North Eugene High School Softball Field

Addendum – 2

June 18, 2020

7. DRAWING SHEET C500

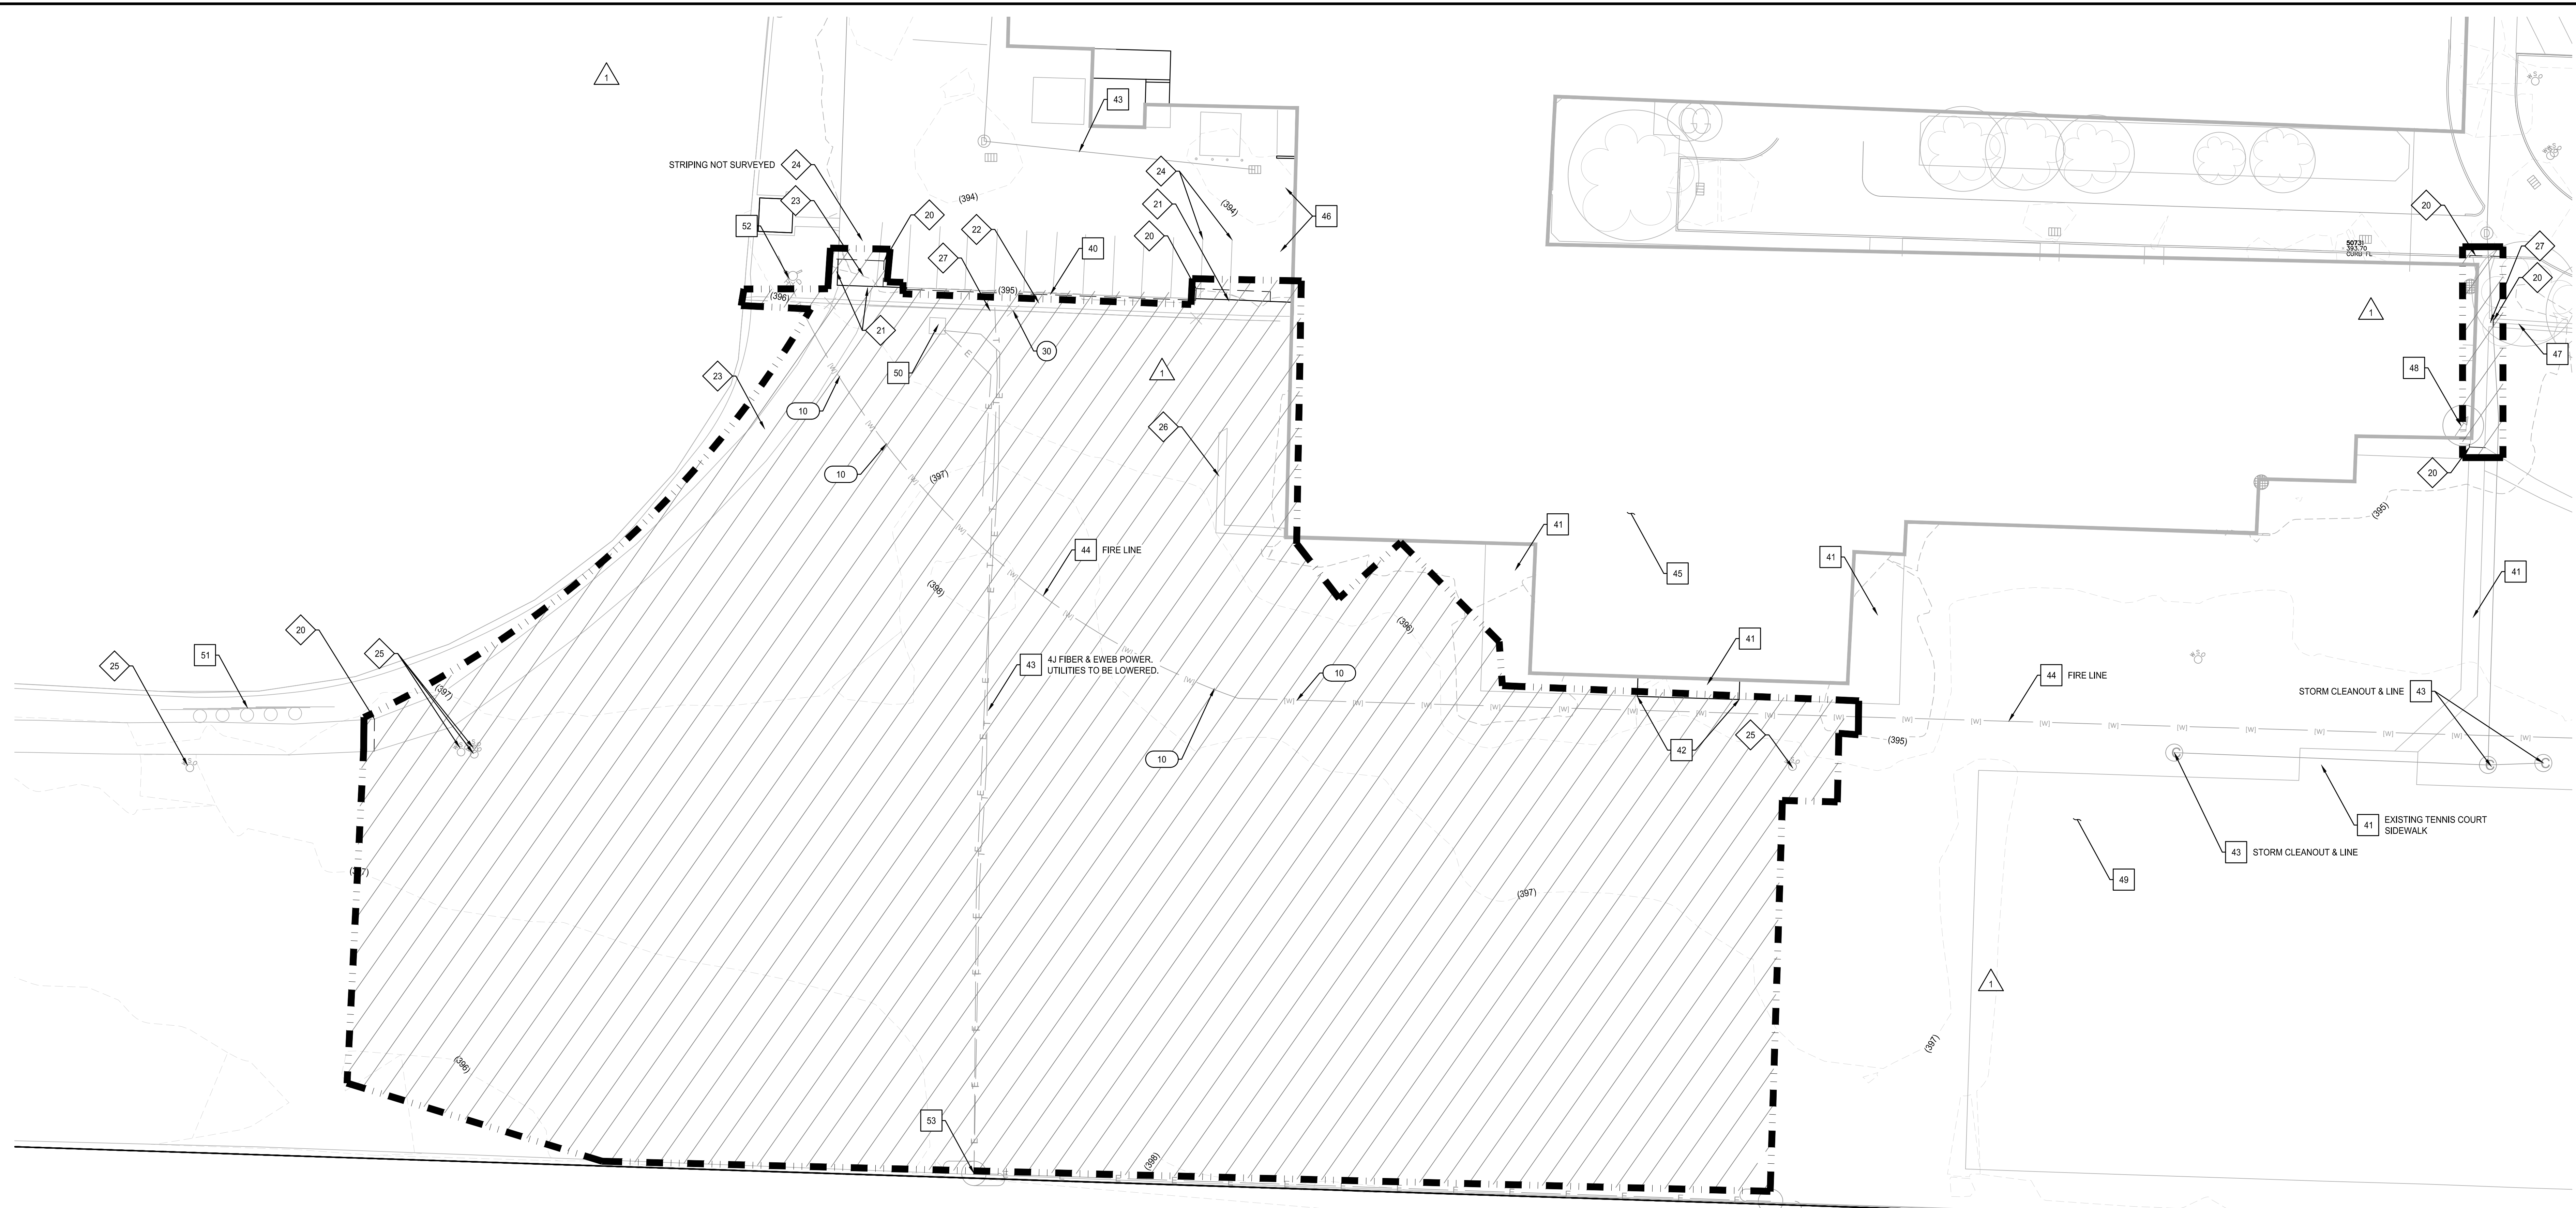
- A. Drawing Sheet C500: Replace with updated Drawing Sheet C500 attached to this Addendum. Clarification:
- i) Revised note for proposed conduit. Conduit is to be contractor installed. Fiber is to be pulled by contractor in coordination with 4J. EWEB to install new power service and contractor to coordinate.

SHEET NO.
C101

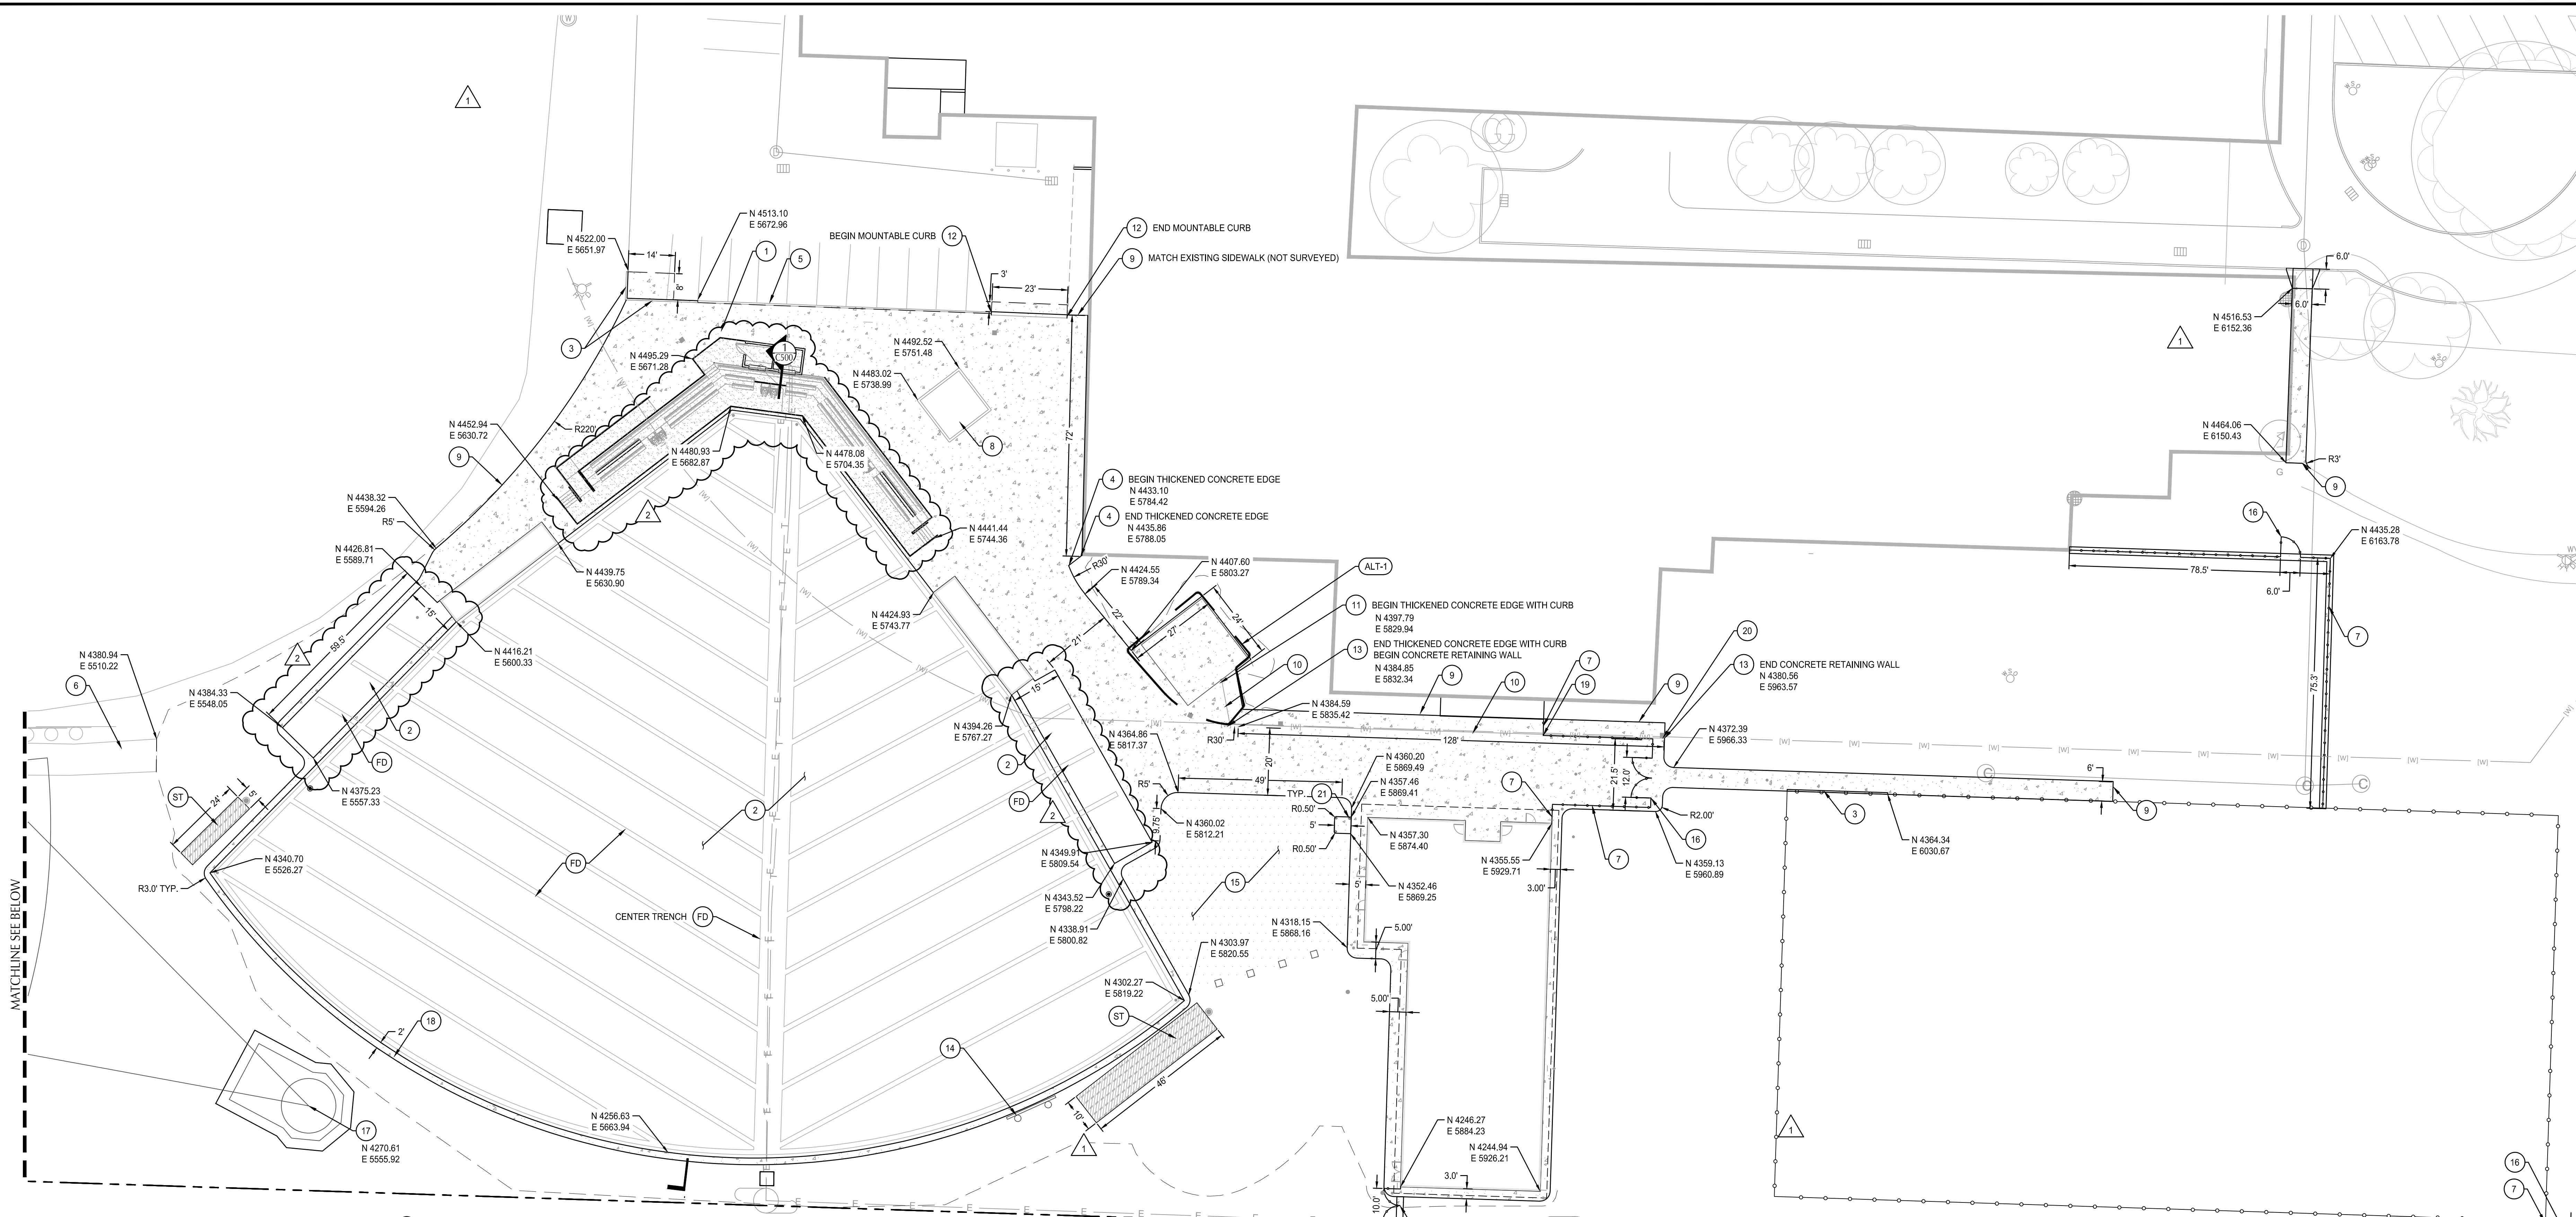
4. DRAWING SHEET C101

A. Drawing Sheet C101: Replace with updated Drawing Sheet C101 attached to this Addendum. Clarification:

i) Added note for security fencing. Contractor to include site security fencing

around perimeter of project site.

C200

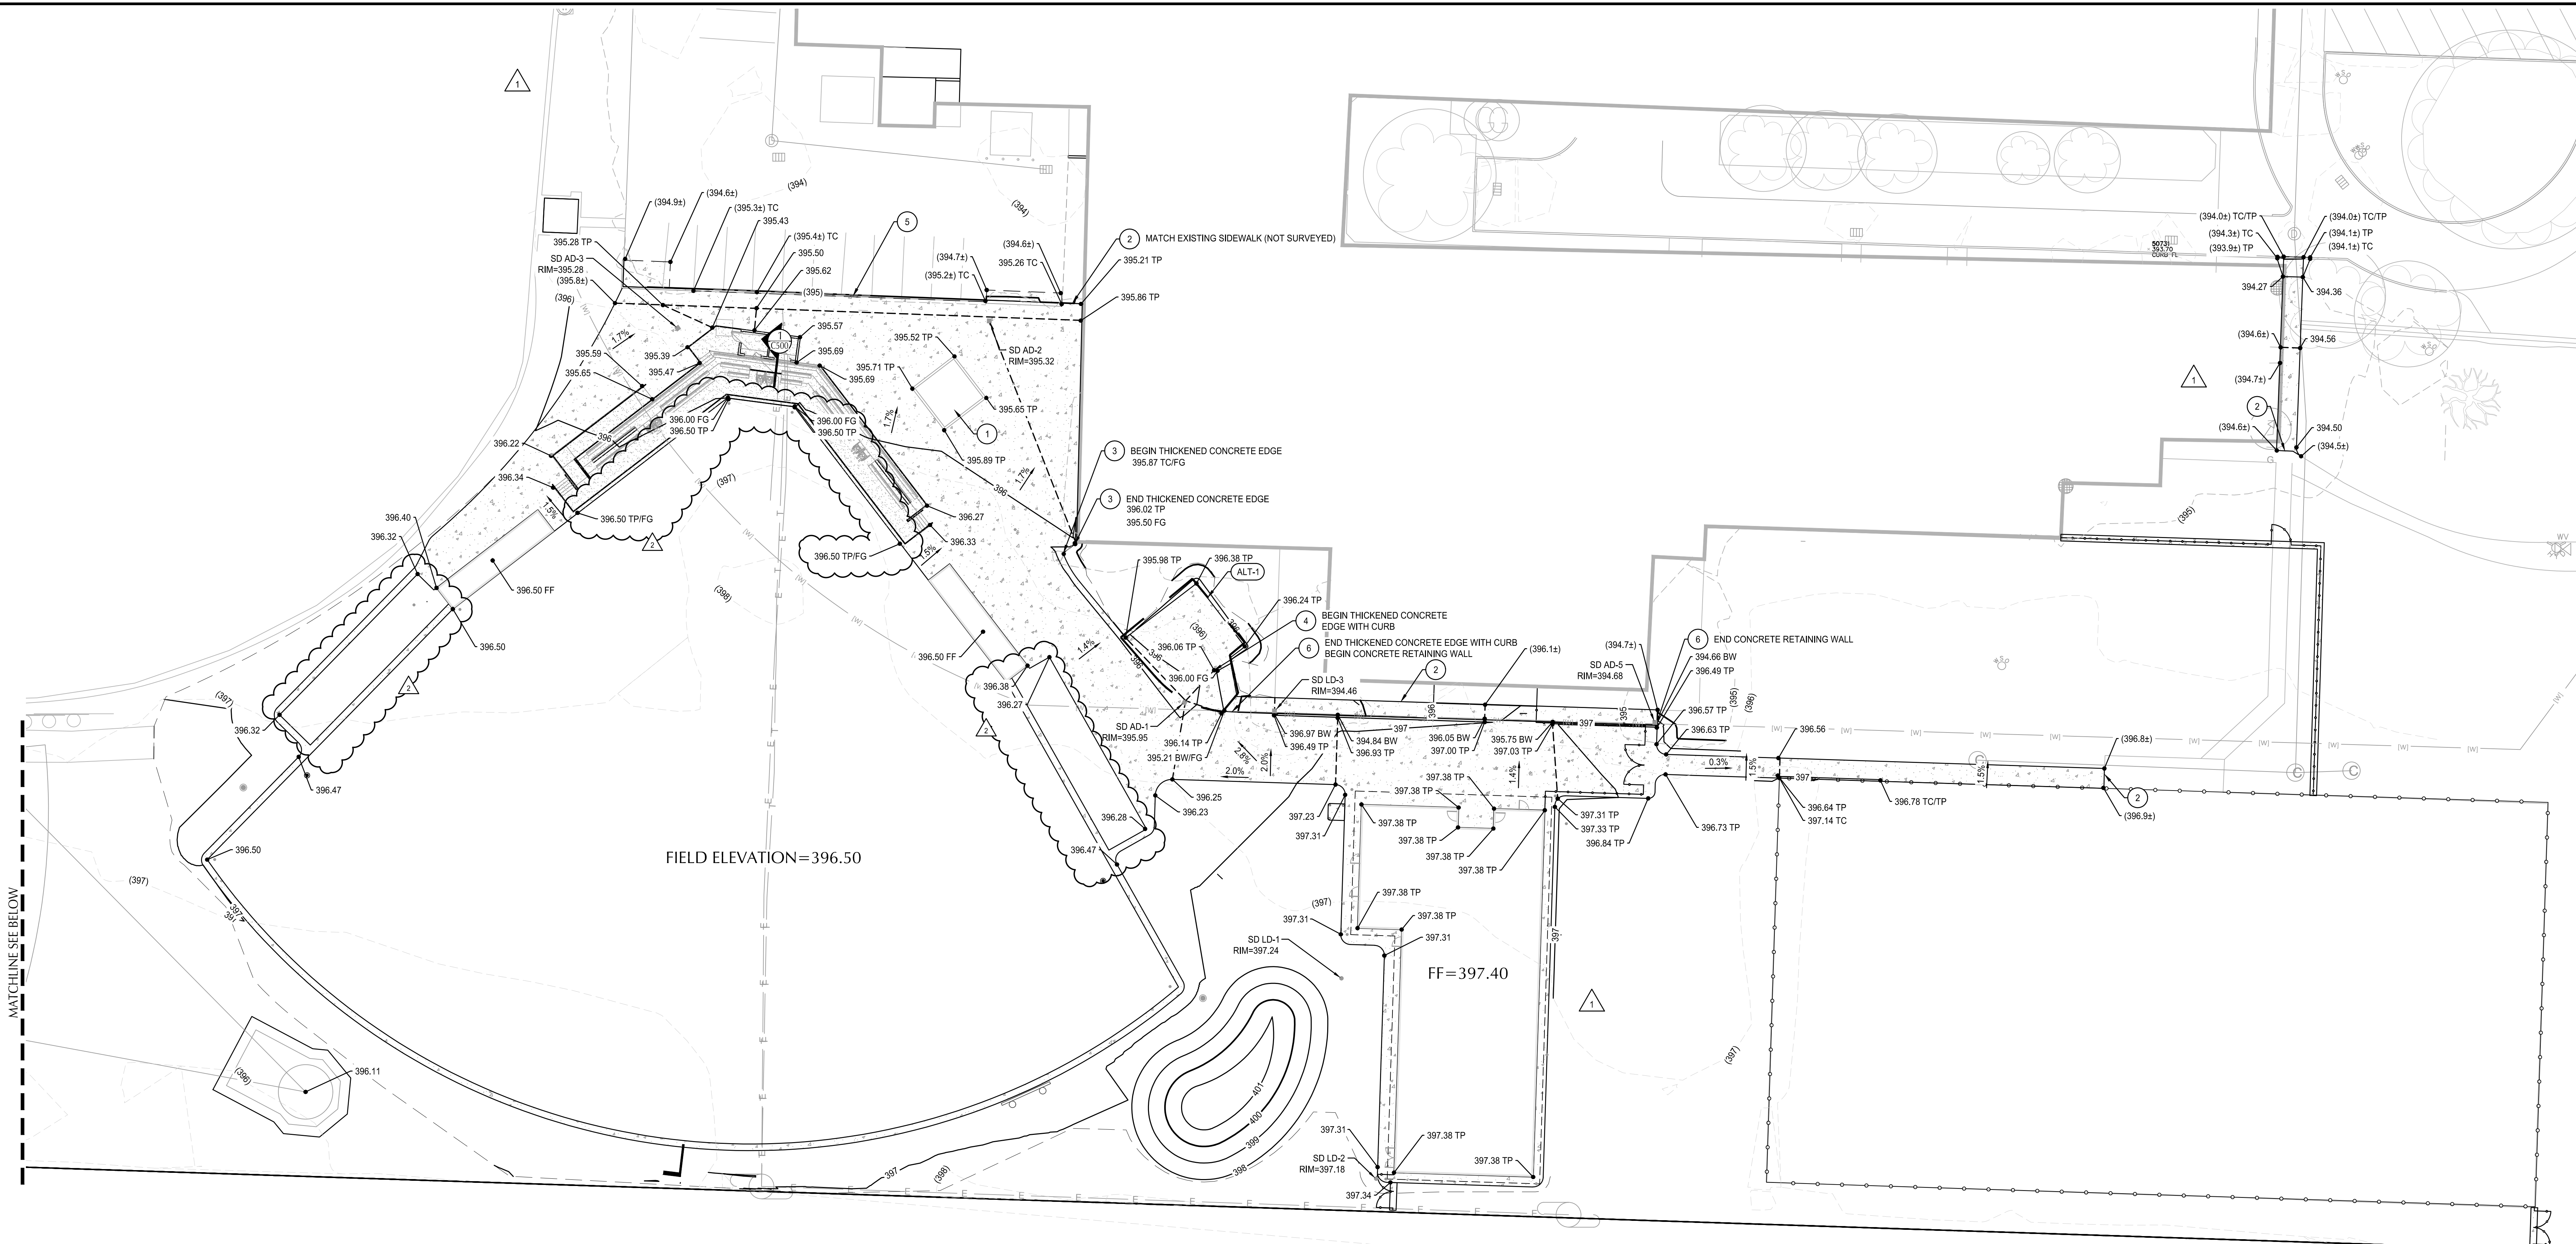
5. DRAWING SHEET C200

- A. Drawing Sheet C200: Replace with updated Drawing Sheet C200 attached to this Addendum. Clarifications:
- i) Revised the sheet note for scoreboard. Scoreboard footings and structure of the scoreboard to be bidder designed in coordination with manufacturer.
 - ii) Added a mow strip between bull pen and playing field to match Architectural.
 - iii) Deleted thickened concrete edge callouts at bleachers. Footing to be provided at backstop per Architectural bleacher section A6/A401.
 - iv) Added hatch for 2" concrete rat slab under bleachers.
